YARRA CITY COUNCIL

Internal Development Approvals Committee

1.1 PLN17/0941 - 390-394 Brunswick Street, Fitzroy - Part demolition of the existing building for the construction of a mixed-use building and a reduction in the statutory car parking requirement.

1. This report provides Council with an assessment of Planning Permit Application PLN17/0941 which affects the land at 390-394 Brunswick Street, Fitzroy and recommends approval, subject to conditions.

Left: Existing shopfront

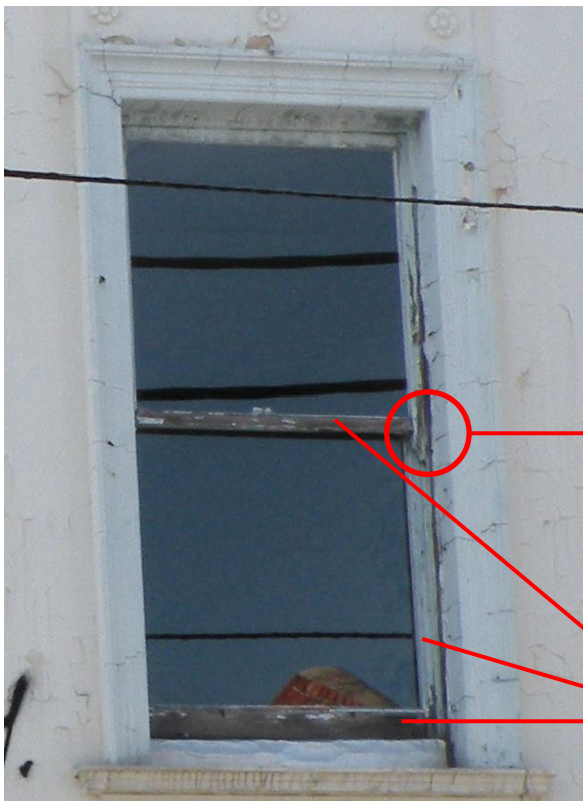
Removal of ground level shop front:

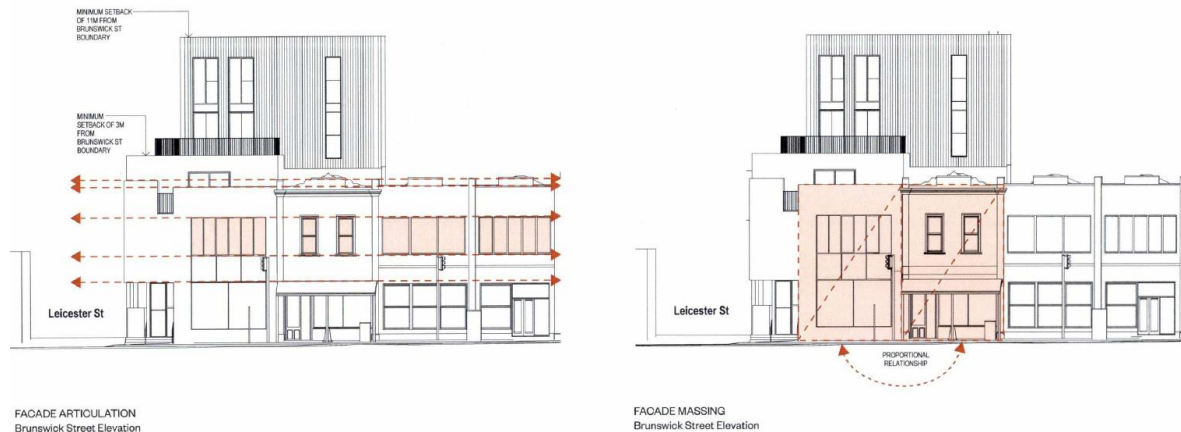
The proposed facade height for the new development will be generally consistent with the height of the adjoining buildings to the south.

Similarly the articulation of the proposed window openings will be consistent with the façade of the adjoining heritage building. Despite the proposed new building being contemporary in appearance,

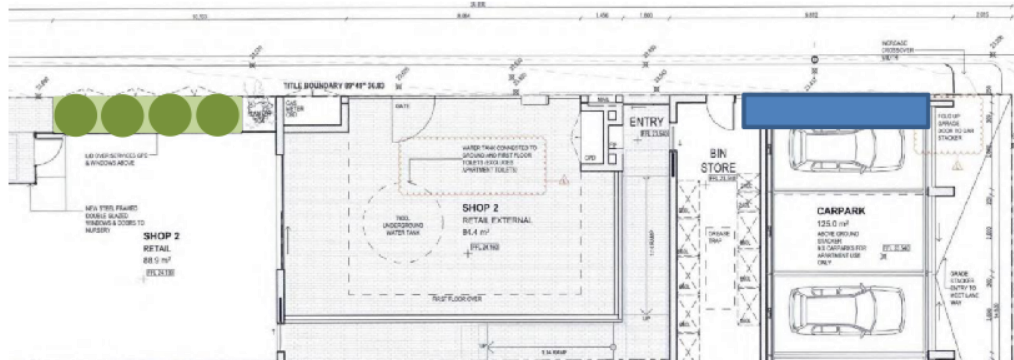
reduce the car parking number and traffic advice might be needed. The leftover space in the car park area can potentially be used for visitor bike parking for retail and office uses.

North Elevation shows that the doors for hydrant booster and water meter will be brick doors and it is unclear about practicality of this.
